E4916A-05

S E R V I C E N O T E

Agilent E4916A Crystal Impedance / LCR Meter

Warning message of “W69 Out of Srch Range” due to defective A1 main board

Figure 1. Spectrum of unlocked source signal

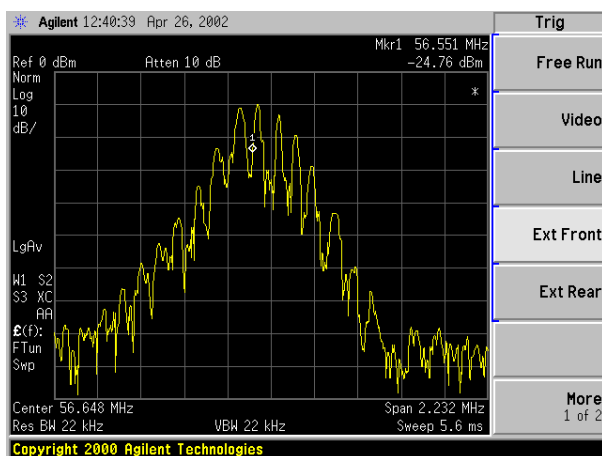
The E4916A equipped with old A1 Main board (P/N E4915-66521) may display a warning message of “W69 Out of Srch Range” when measuring a crystal resonator or filter at frequencies near 55 MHz. As a result, measurement is disabled. The PLL frequency synthesizer of the A1 Main board that fails in phase-lock causes this problem. To verify if the PLL is unlocked, check the source output signal at -5 dBm at 55 MHz by using a spectrum analyzer. Figure 1 shows an example of unlocked source signal on spectrum display compared to normal source signal (Figure 2).

Replace the old A1 board with new A1 board (P/N E4915-69531).
